FIELD CHANGE ORDER

TU77A

M

0007

FIGURE 1

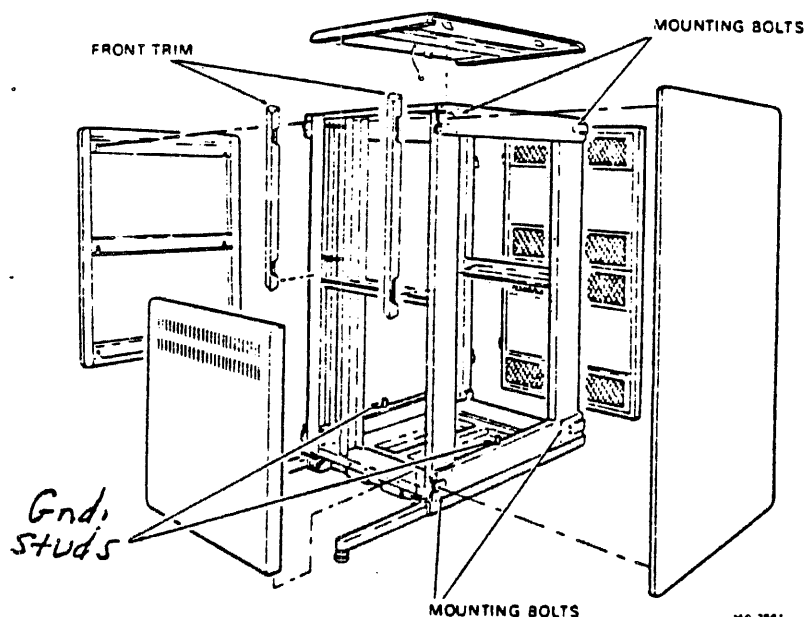
THE TU77 MANUALS DO NOT MENTION THE INSTALLATION OF THE GROUND STRAP, PN 74-12827-25 WHICH IS SHIPPED WITH EVERY SYSTEM.

THE STRAP SHOULD RUN FROM ONE OF THE GROUND STUDS ON EITHER LOWER SIDE STRUT TO THE HOST CPU. SEE FIGURE 1. THE MANUALS WILL BE CORRECTED.

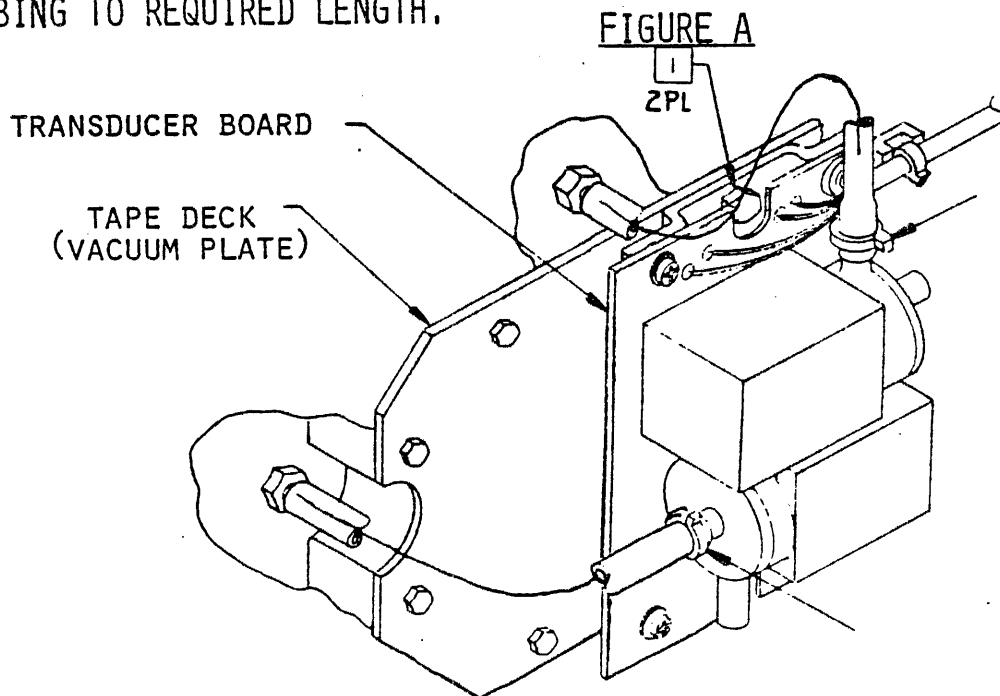
THERE IS A NEW TYPE OF TRANSDUCER ASSEMBLY BEING INTRODUCED BY PERTEC. IT IS COMPLETELY INTERCHANGEABLE WITH THE PRESENT ONE. THE PART NUMBER 29-23246-00 WILL NOT CHANGE.

1. REMOVE TRANSDUCER BOARD, PNEUMATIC TUBING, AND WIRING (SEE FIGURE A) DISCARD. SAVE EXISTING HARDWARE. (SEE #1 OF FIGURE A)
2. INSTALL NEW TRANSDUCER ASSEMBLY WITH EXISTING HARDWARE.
3. CONNECT PNEUMATIC TUBING AND TIE WRAPS AS SHOWN IN FIGURE B. CUT TUBING TO REQUIRED LENGTH.

FIG 1

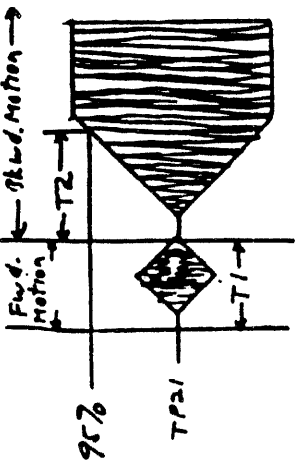
With the Rev G change to the M2 module, 29-23774, a logic change is being incorporated in the TU77. This additional logic adds what is referred to as a "Forward Hitch", when a reverse tape motion is attempted after a delay of 10 to 20 ms.

For the TU77, this logic also changes the waveform that is seen during capstan ramp adjustment on Pin 21 of the Rev G and above M2 module. Fig. 1 shows the waveform that will be seen on TP21 with this change installed.

T2 time frame, which is the actual backward start ramp, is adjustable and should be 3.0 ms ± .15 ms (2.85 - 3.15 ms).

This hitch will not be present between consecutive forward tape motions. It will only be present before reverse tape motion, when 10-20 ms has elapsed since the previous command.
